Comment Report

Std. 802.2, 1998 Edition and Amendments Reaffirmation

Ballot closed: 2003-03-11

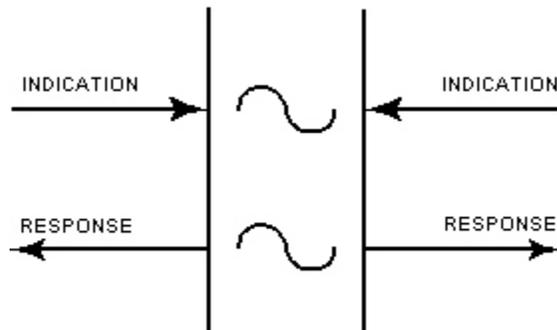
Comment: In Figure 3, the tilde "~" symbol is not explained in the paragraph above the figure.

This comment does not need to be resolved before publication.

Suggested remedy: Define the use of the tilde "~" symbol in the paragraph preceding Figure 3.

Committee Comment: Accepted in principle. These markings in Figure 3, parts (d), (e), and (g), are not intended to represent the tilde character. They were originally conventional markings for time sequence diagrams, representing an indeterminate time relationship.

The confusion could best be resolved by reverting to the more conventional depictions in the first (1989) edition of ISO 8802-2, which looked like the following figure.
